VILLAGE OF GERMANTOWN
N112 W17001 MEQUON ROAD
GERMANTOWN, WI 53022

MEETING:	PLAN COMMISSION
DATE AND TIME:	MONDAY, APRIL 8, 2019 6:30 p.m.
LOCATION:	Germantown Village Hall Board Room

SHEET
C0.02

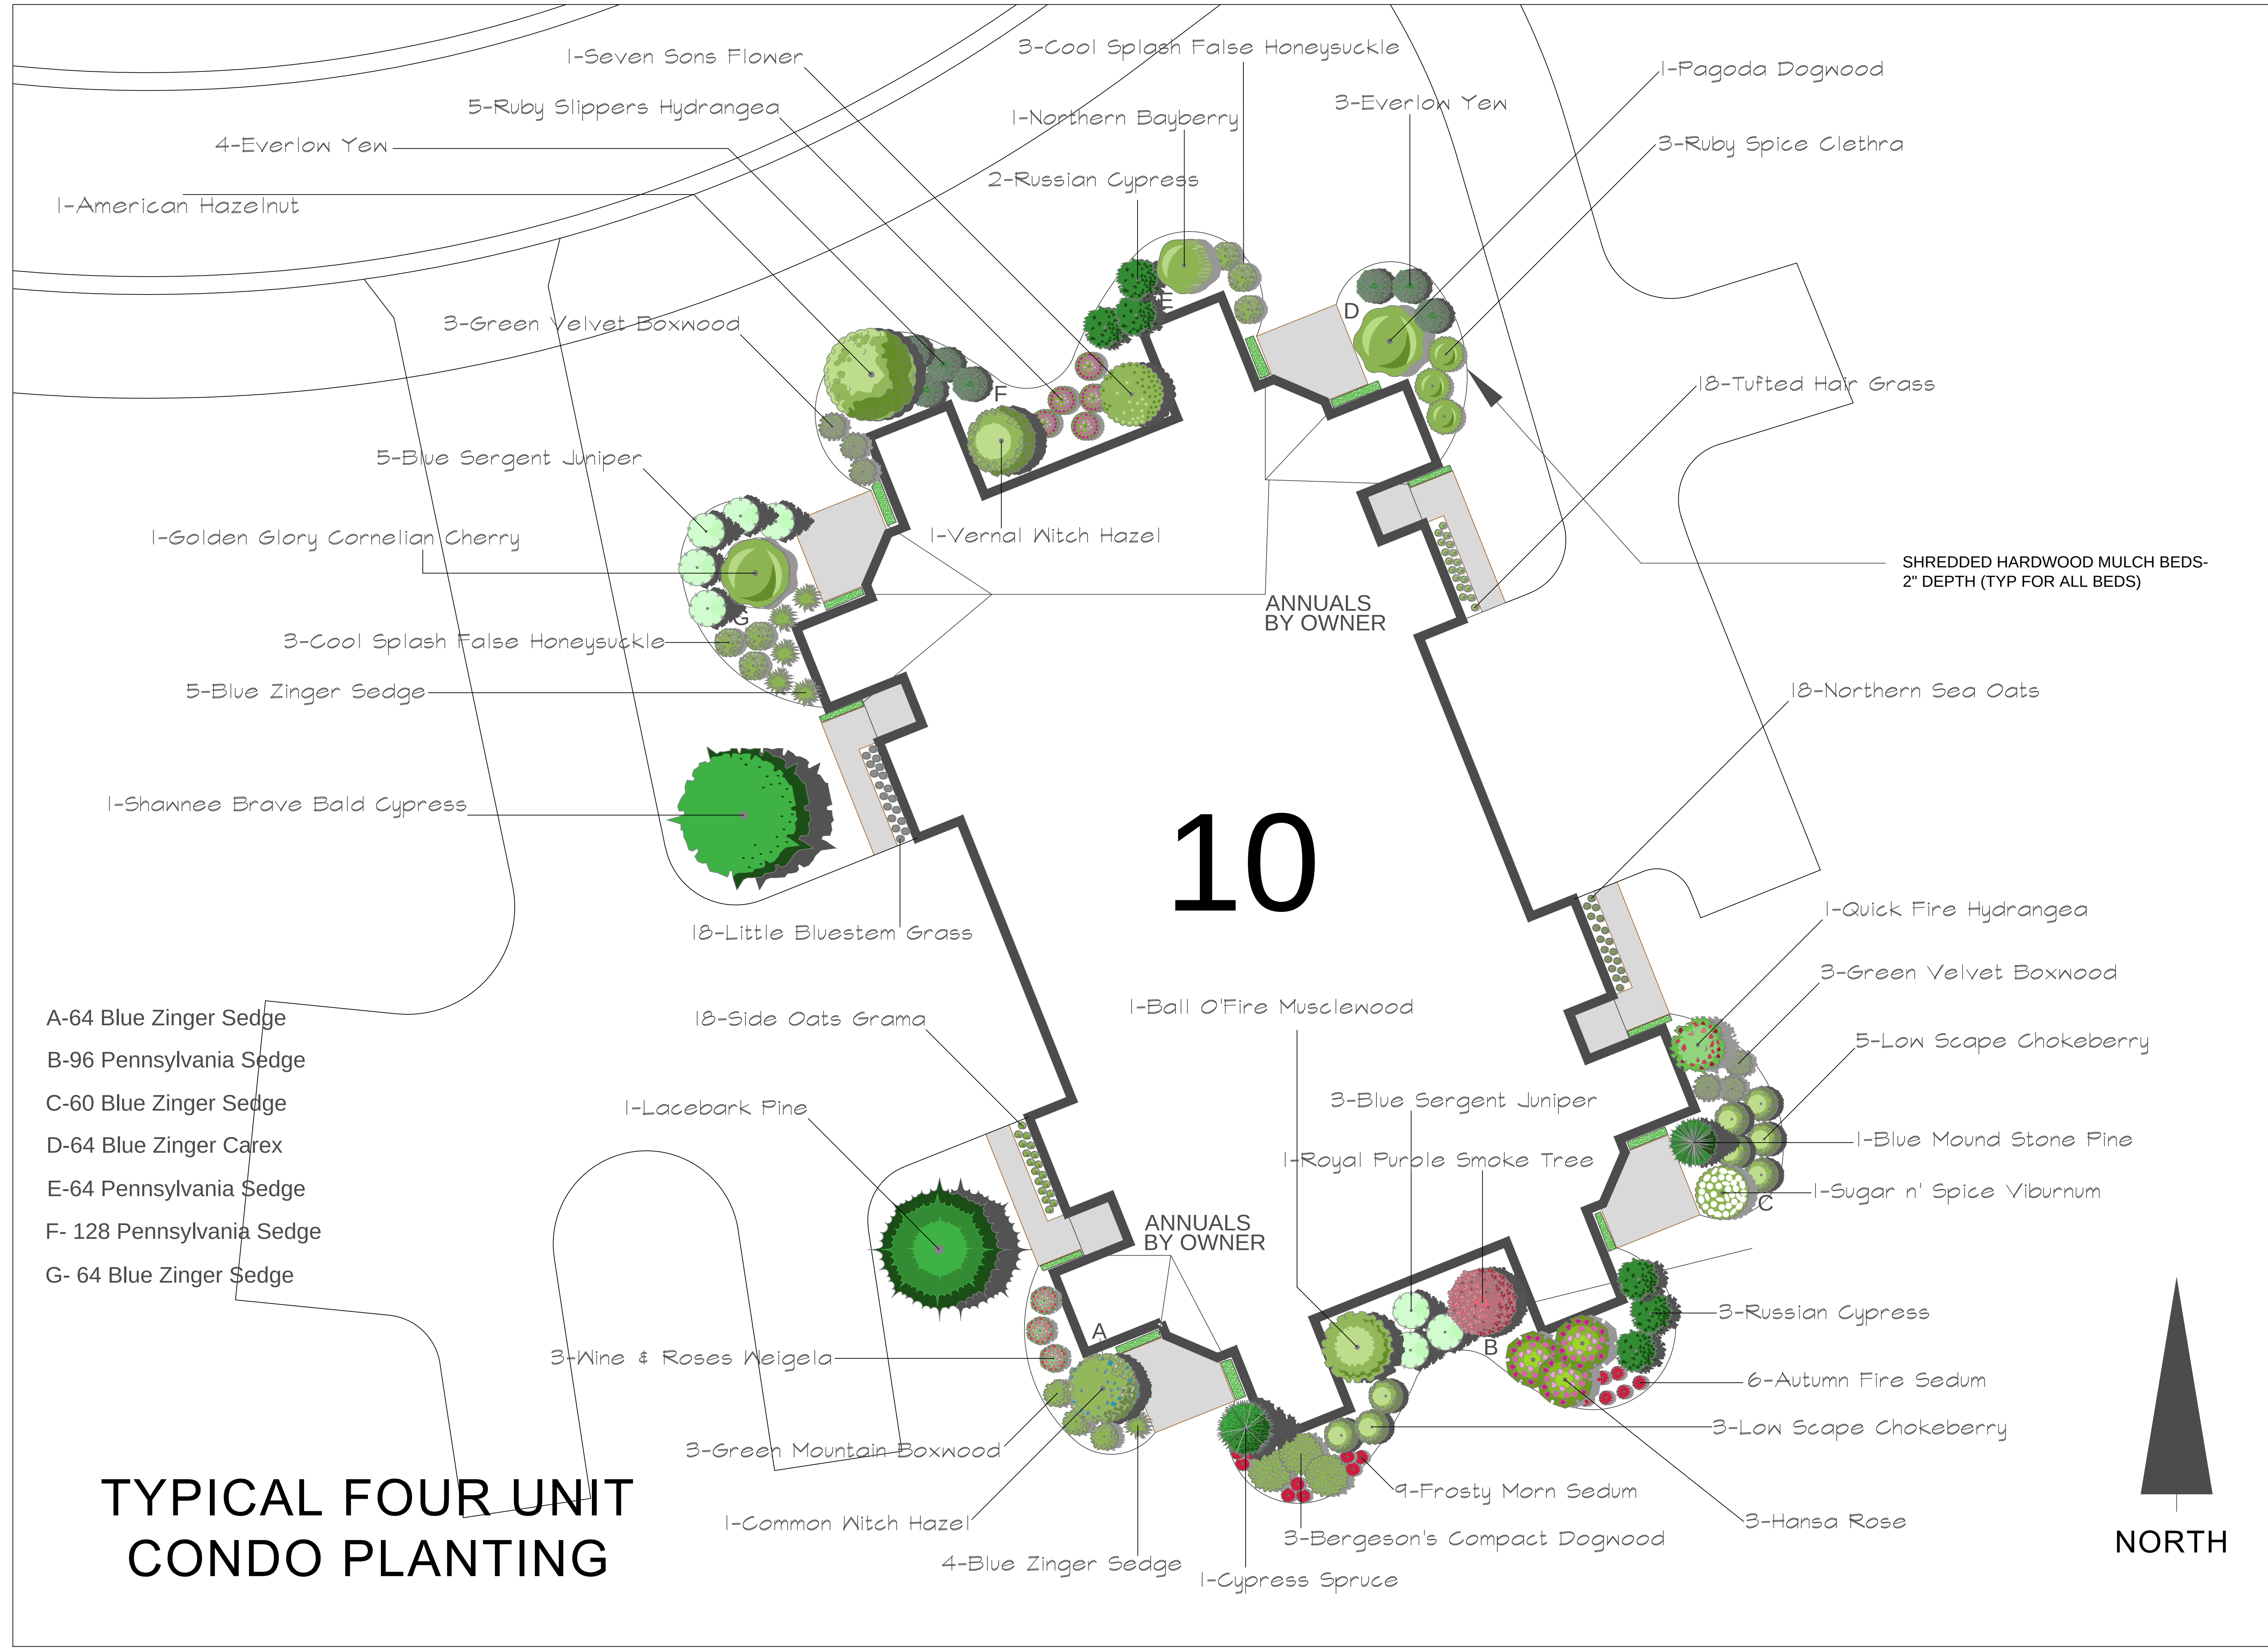
As presented in the Site Plan (Sheet C0.02), the development is comprised of fifteen (44) total multi-family condominium units in 2-unit and 4-unit buildings (15 total buildings). A condominium community clubhouse with a small kitchen & bar, rec room w/ vaulted ceilings, outdoor patio area with seating and a built-in grill. A putting green, bocce ball court, paved sidewalk and off-street parking will also be provided.
